APPENDIX F - BASE FLOOD ELEVATION MEMORANDUM

Base Flood Elevation Memorandum

Regarding: COSTCO GAS STATION – Entitlement 1st plan check comments

ATTACHMENT 1

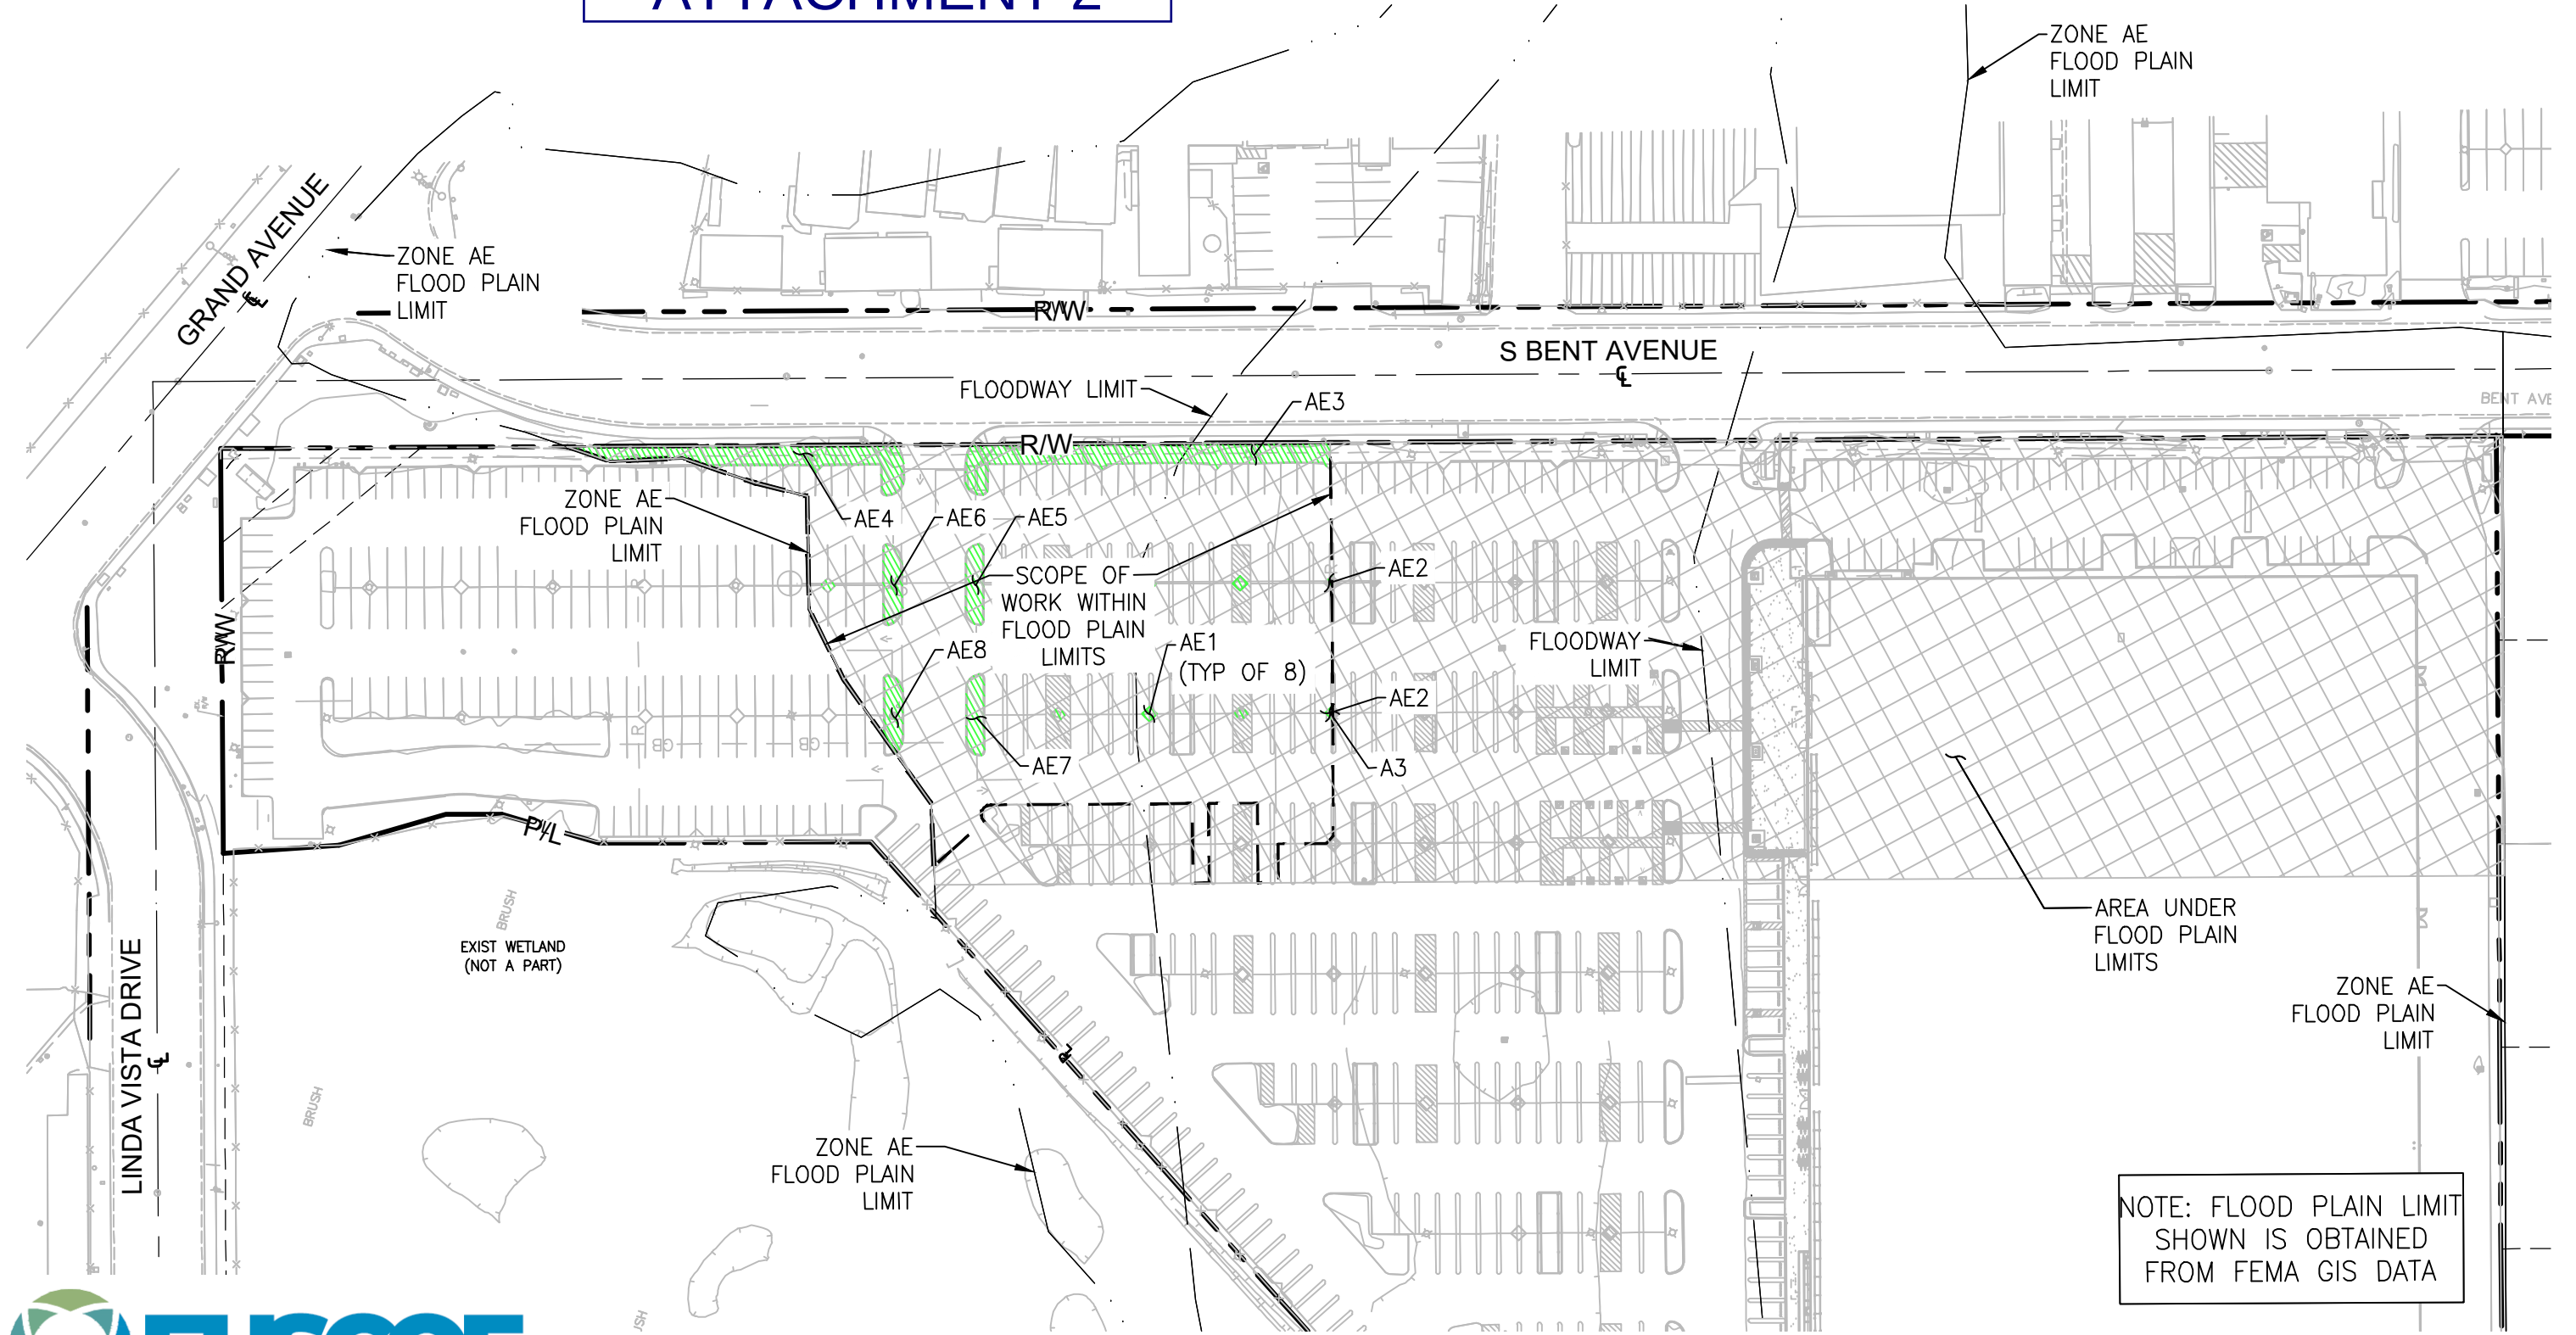
Proposed Conditions			Existing Conditions		
Island areas <

ATTACHMENT 2

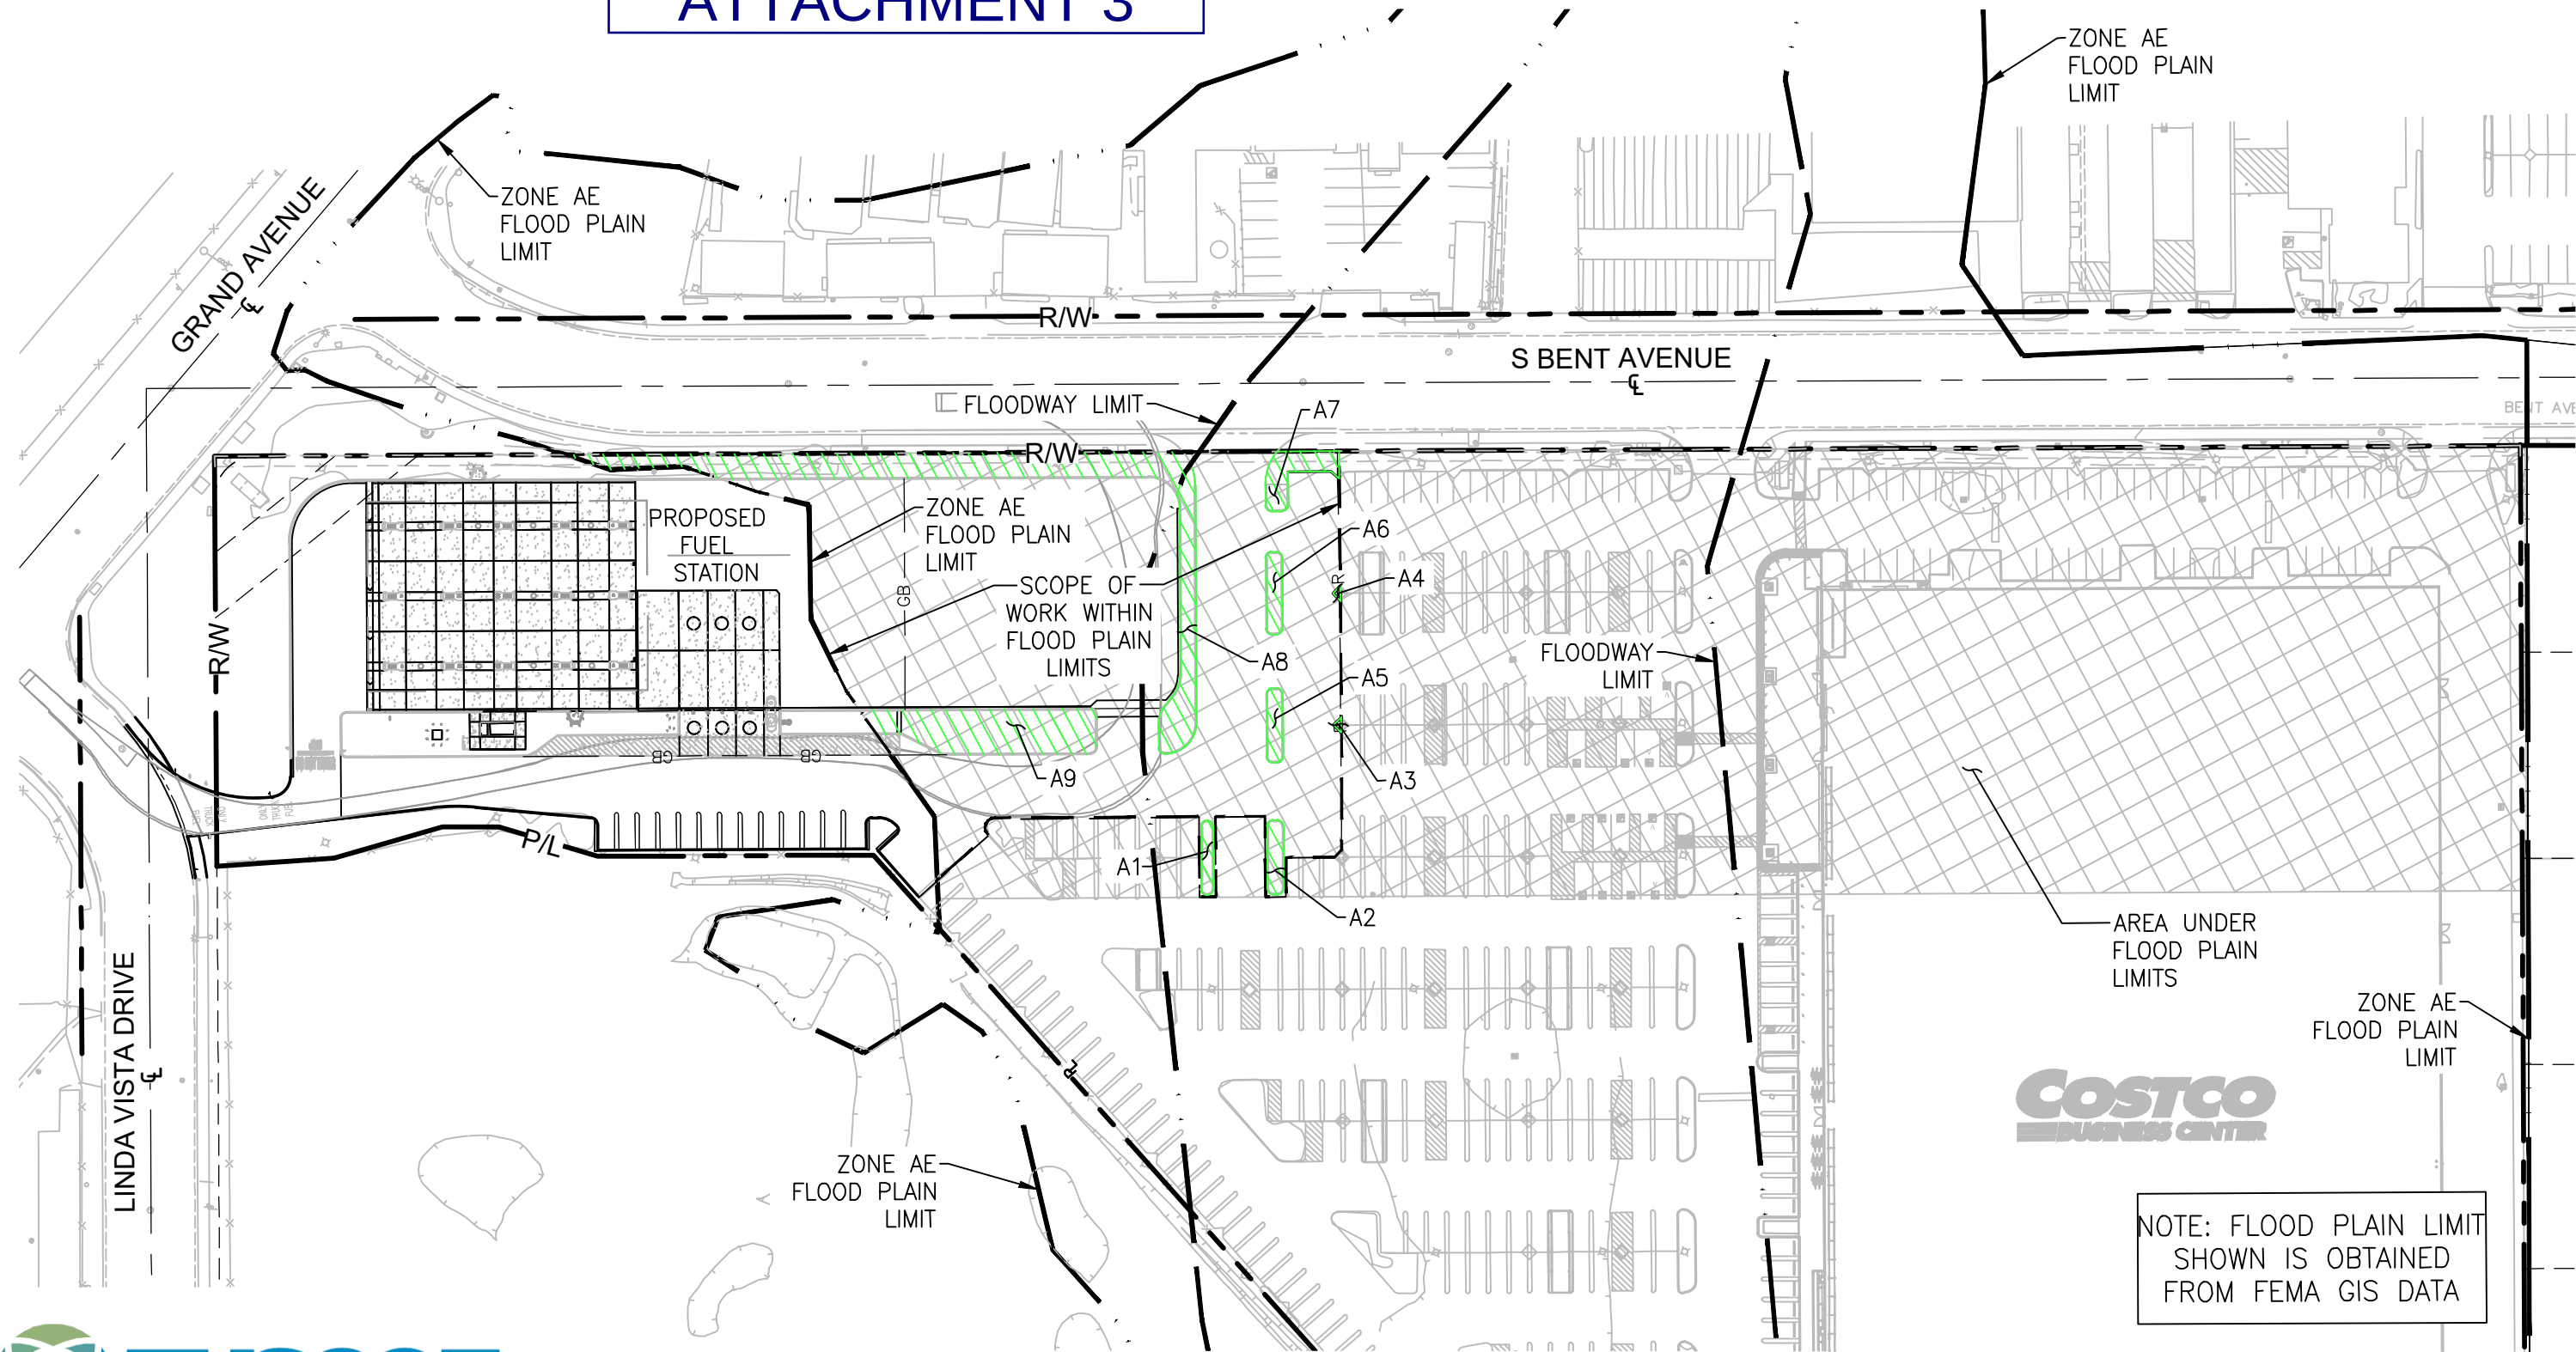
EXISTING CONDITIONS
01/09/24
◇ EXIST PLANTERS WITHIN FLOODWAY
6" CURB - VOLUME = 2,550 CF

ATTACHMENT 3

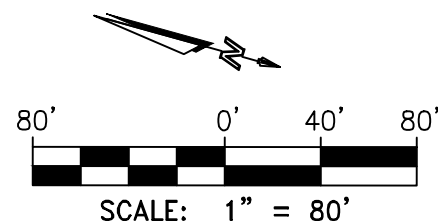
- PROPOSED PLANTER LOCATIONS WITHIN FLOOD PLAIN
- 6" CURB - VOLUME = 4,250 CF
- 4" CURB - VOLUME = 2,800 CF
